UNITED STATES PATENT AND TRADEMARK OFFICE

APPLICATION NO.	FILING DATE	FIRST NAMED INVENTOR	ATTORNEY DOCKET NO.	CONFIRMATION NO.
10/718,561	11/24/2003	Myoung-Kee Baek	42165-0009	1881
30827	7590	02/08/2006		
MCKENNA LONG & ALDRIDGE LLP 1900 K STREET, NW WASHINGTON, DC 20006			EXAMINER EVANISKO, LESLIE J	
			ART UNIT 2854	PAPER NUMBER

Office Action Summary	Application No. 10/718,561	Applicant(s) BAEK ET AL.	
	Examiner Leslie J. Evanisko	Art Unit 2854

DETAILED ACTION

FIG. 7B

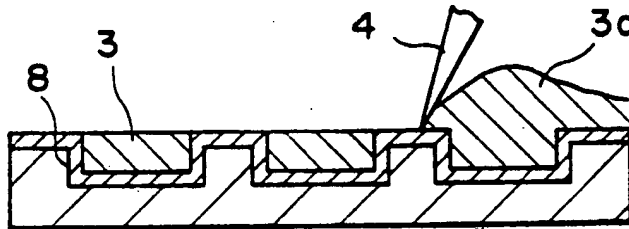
With respect to claim 10, Okazaki et al. teach depositing the resist material 3 along the entire surface of the cliché 1 and contacting a doctor blade 4 onto the surface of the cliché to flatten the resist material and fill the resist material into the grooves and remove the resist material that remains on the surface. See Figures 1C-1, 6B, and 7B and column 4, lines 54-61 in particular.

FIG. 7C

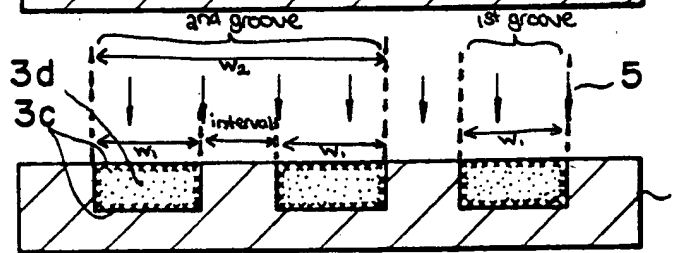
appears that the cliché shown in Figures 6A-6D, 7A-7E, and 8A-8C of Okazaki et al. meet that relationship--as pointed out by the Examiner in the marked-up copy of Figures 6B, 7C, and 8B attached to this Office Action, which illustrates what structure the Examiner is considering to be the first and second groove structures and interval as recited. Regardless, it would have been obvious to one of ordinary skill in the art to provide a cliché having first and second groove structures with the size relationship as recited, as the particular sizes and arrangements of the groove structures of the cliché are dependent upon such factors as the particular configuration of the pattern desired to be printed, the desired thickness of pattern to be printed, the viscosity of the material being printed on the substrate, etc.

FIG. 7D

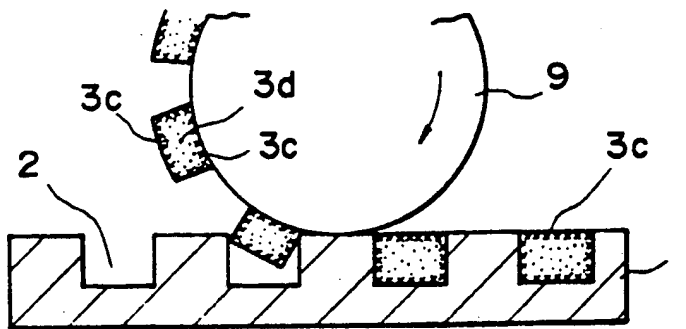
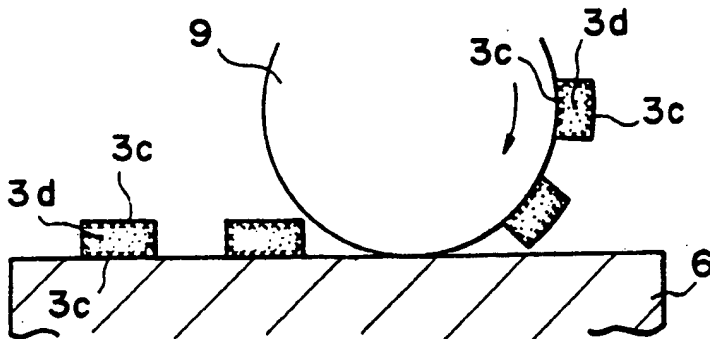
With respect to claim 5, note Okazaki et al. teach applying the resist material 3 onto an etching object layer comprises contacting and rotating a printing roll 9 onto the cliché 1 to transfer the resist material to a surface of the printing roll and contacting the resist material formed on the surface of the printing roll to transfer the material to an etching object layer of the substrate 6, as shown in Figures 7D-7E and 8B-8C in particular.

FIG. 3A

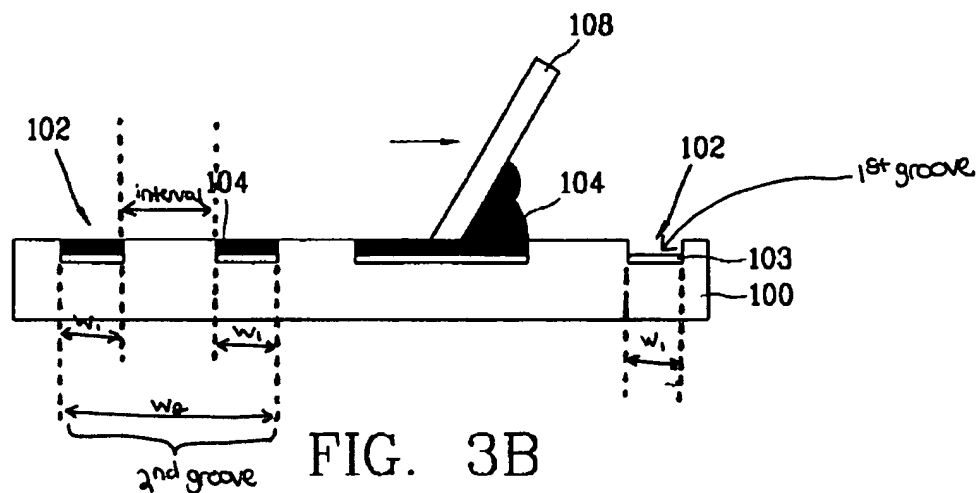
With respect to claim 10, Kwon et al. teach depositing the resist material along the entire surface of the cliché and contacting a doctor blade onto the surface of the cliché to flatten the resist material and fill the resist material into the grooves and remove the resist material that remains on the surface. See column Figure 3(a) and paragraph [0029] in particular.

FIG. 3B

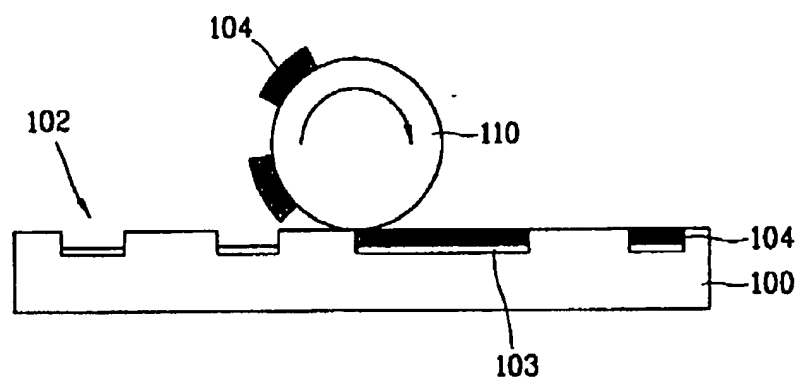
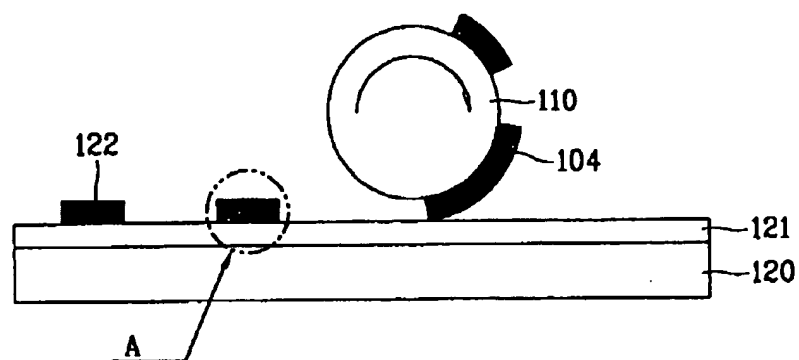
With respect to claim 5, note Kwon et al. teach applying the resist material 104 onto an etching object layer 121 comprises contacting and rotating a printing roll 110 onto the cliché 100 to transfer the resist material to a surface of the printing roll and contacting the resist material 104 formed on the surface of the printing roll to transfer the material to an etching object layer 121 of the substrate 120, as shown in Figures 3(b) and 3(c) in particular.
